**CITY OF CHESTERFIELD
PLANNING COMMISSION MEETING
MONDAY - FEBRUARY 12, 2007
7:00 PM**

Planning Commission Staff Report

RE: Conway Point Office Building – January 12, 2007 Submittal
PZ 16-2006, R3 to PC

RE: Conway Point Office Building – December 11, 2006 Submittal
PZ 16-2006, R3 to PC

Designed SWQ
Drawn SLH
Checked EAS
Date 09/14/06
Project Number 98218.3
Sheet Number 1 of 3

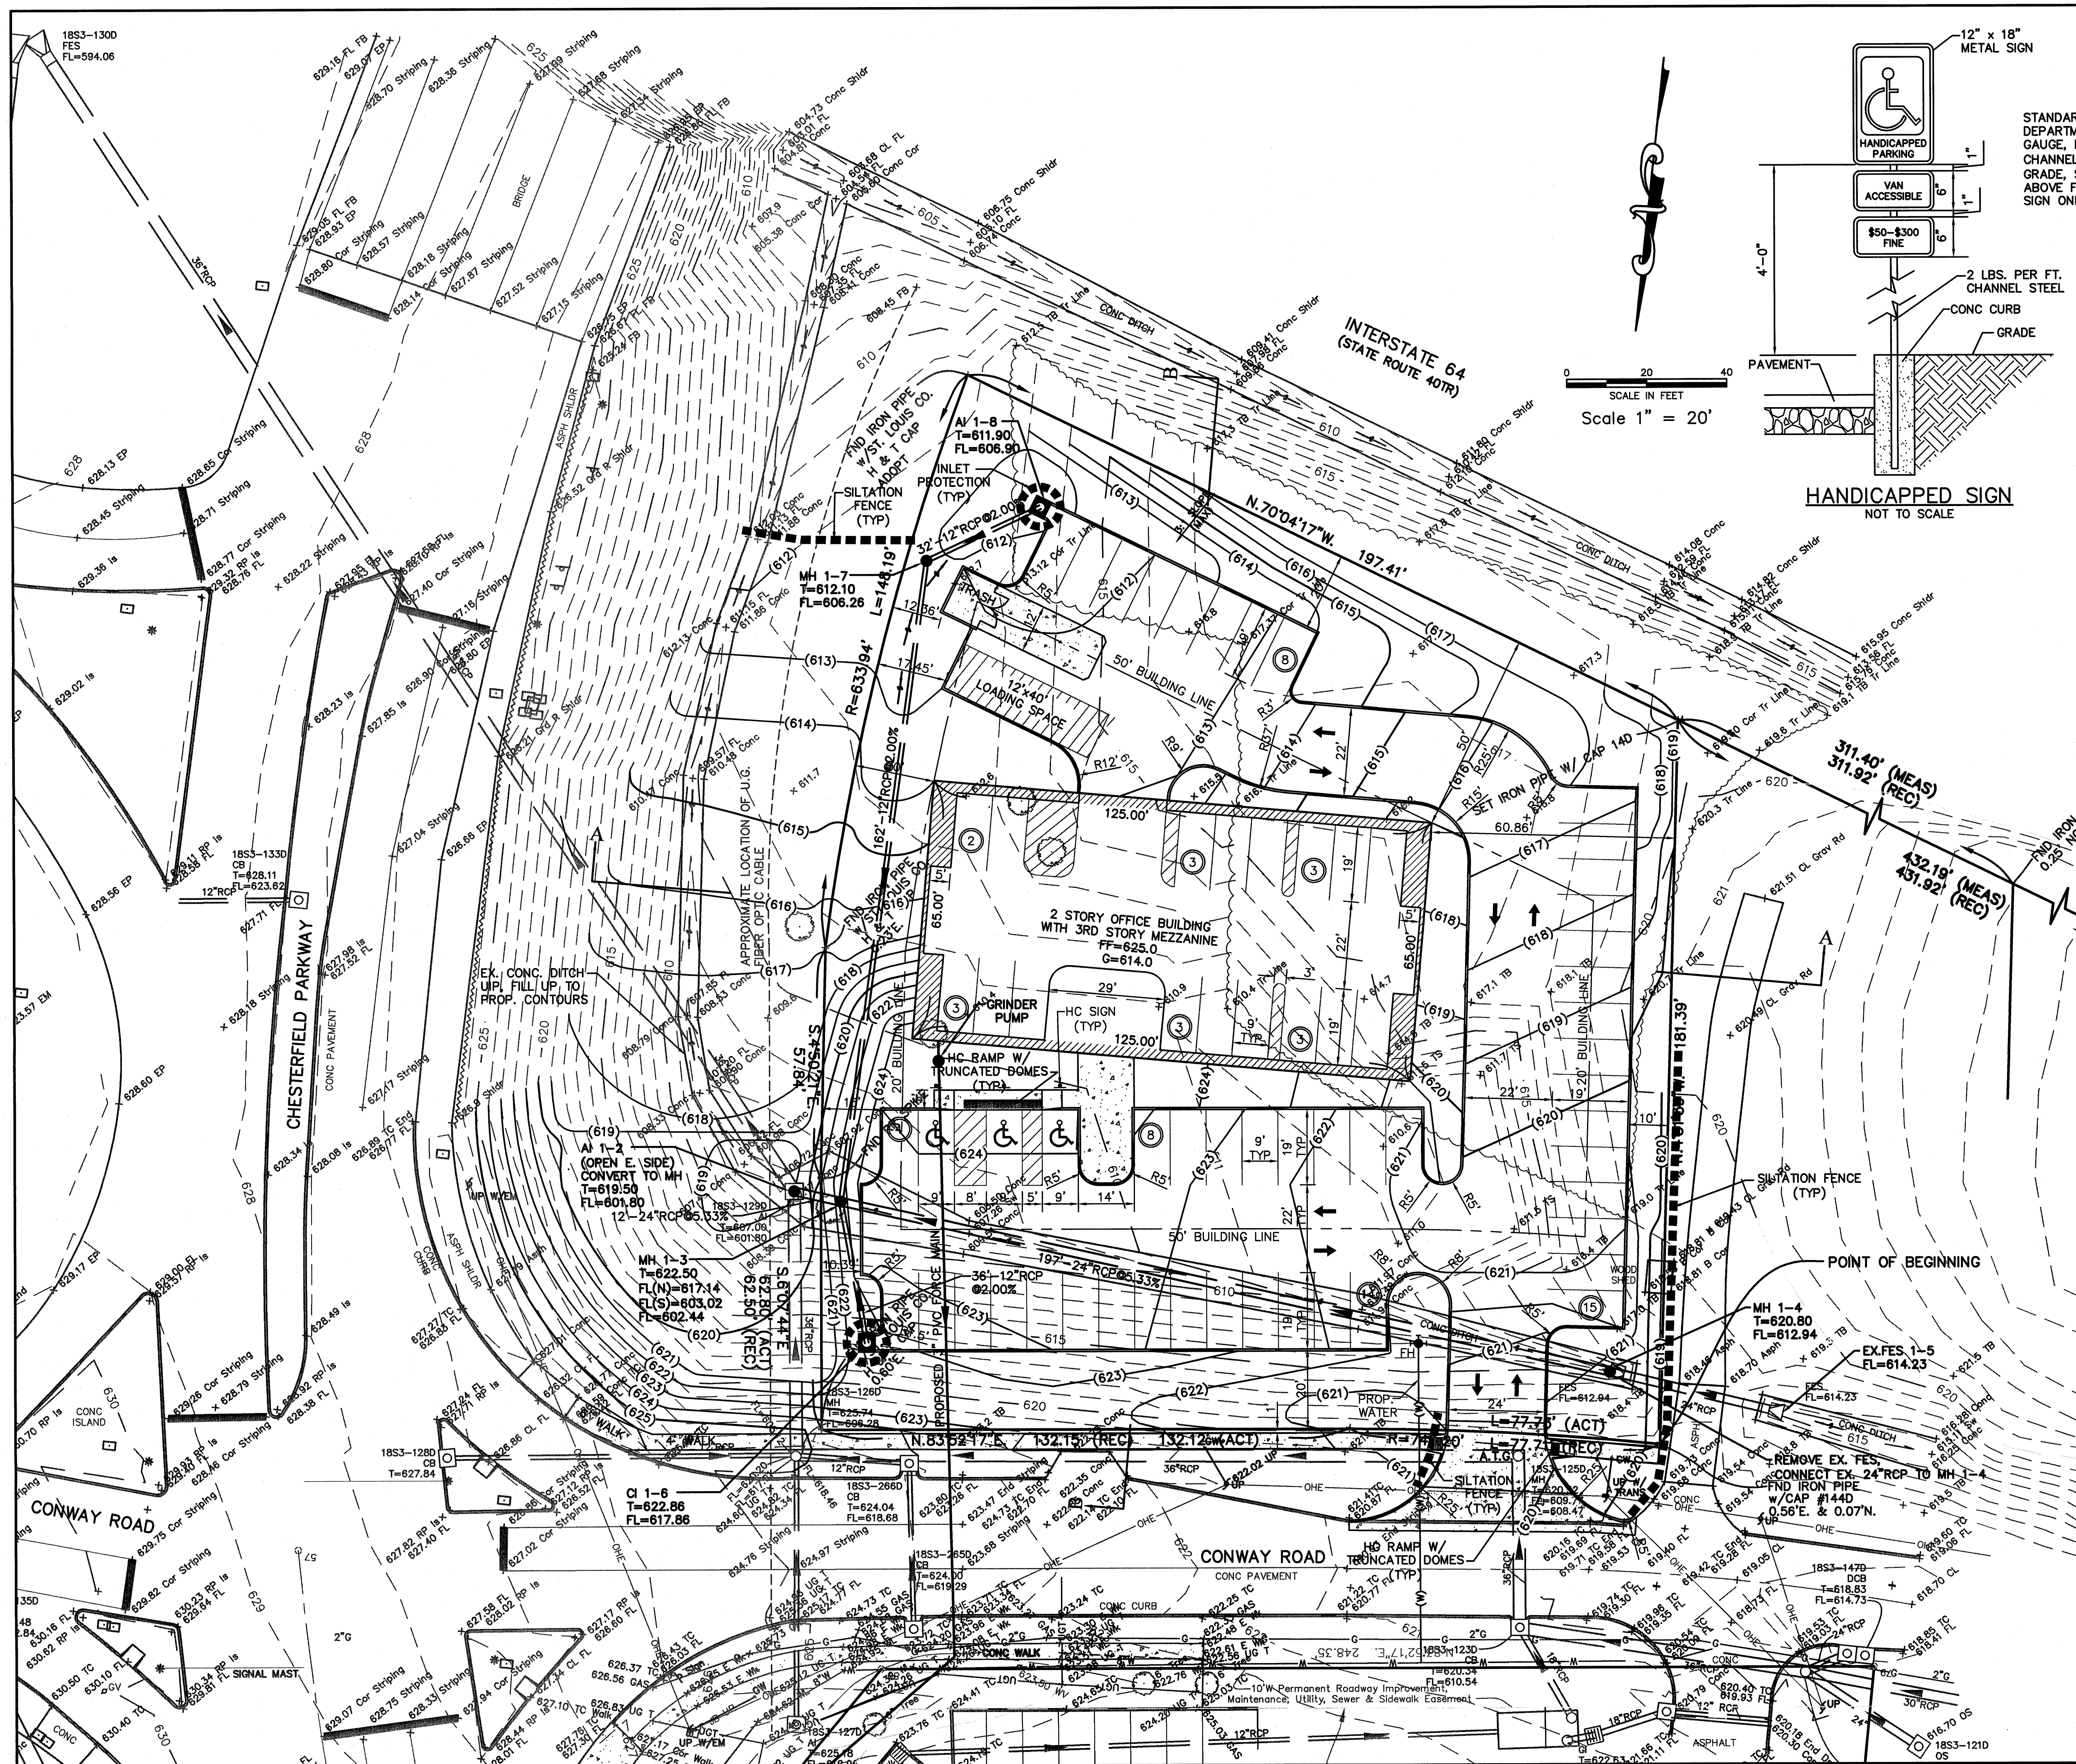
5. On sheet 1 of 3, portions of the sanitary force main appear to be located outside the existing utility easement. Either the force main alignment will require revision or additional easements obtained. This issue need not be addressed at this time, but will be reviewed in greater detail during review of the Improvement Plans.

5. On sheet 1 of 3, portions of the sanitary force main appear to be located outside the existing utility easement. Either the force main alignment will require revision or additional easements obtained. This issue need not be addressed at this time, but will be reviewed in greater detail during review of the Improvement Plans.
